Access Compliance Report

Public Rights-of-Way

Intersection ID: 53413	Main Street: GOLF_LINKS_DR	Cross Street: WAVERLY_WALK_AV	Location: NE
ADA ID: 8EA01EAB0039	Ramp Type: Perpendicular	Initial Pass/Fail: Fail	Overall Compliance: No
		Severity Score: 12.5

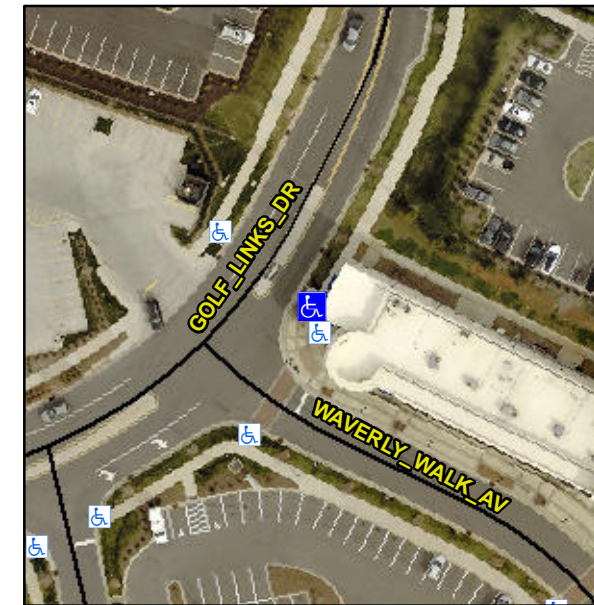
R304.2.2

Compliance	Description	Data	Compliance	Description	Data
N/A	Ramp Length (in)	96.0	No	Ramp Slope (%)	8.4
Yes	Ramp Width (in)	70.0	Yes	Ramp XSlope (%)	0.4
N/A	Flare Type LT	N/A	N/A	Flare Type RT	N/A
N/A	Flare Slope LT (%)	N/A	N/A	Flare Slope RT (%)	N/A
N/A	Flare Traversable LT?	N/A	N/A	Flare Traversable RT?	N/A
N/A	Landing Length (in)	N/A	N/A	DWS Provided?	N/A
N/A	Landing Width (in)	N/A	N/A	DWS Contrast?	N/A
N/A	Landing Slope (%)	N/A	N/A	DWS Length (in)	N/A
N/A	Landing X Slope (%)	N/A	N/A	DWS Full Width?	N/A
N/A	Landing Curb? (Y/N)	N/A	N/A	DWS Offset (in)	N/A
N/A	Shared Landing?	N/A			
N/A	Gutter Ponding?	N/A	N/A	Gutter Slope (%)	N/A
N/A	Gutter Lip Ht (in)	N/A	N/A	Gutter X Slope (%)	N/A
N/A	Painted X Walk1?	No	N/A	Painted X Walk2?	N/A
	X Walk 1 Direction	To NW		X Walk 2 Direction	N/A
N/A	X Walk 1 Width (in)	N/A	N/A	X Walk 2 Width (in)	N/A
	X Walk 1 Slope (%)	3.3		X Walk 2 Slope (%)	N/A
	X Walk 1 X Slope (%)	2.6		X Walk 2 X Slope (%)	N/A

Remove & Replace Entire Ramp.
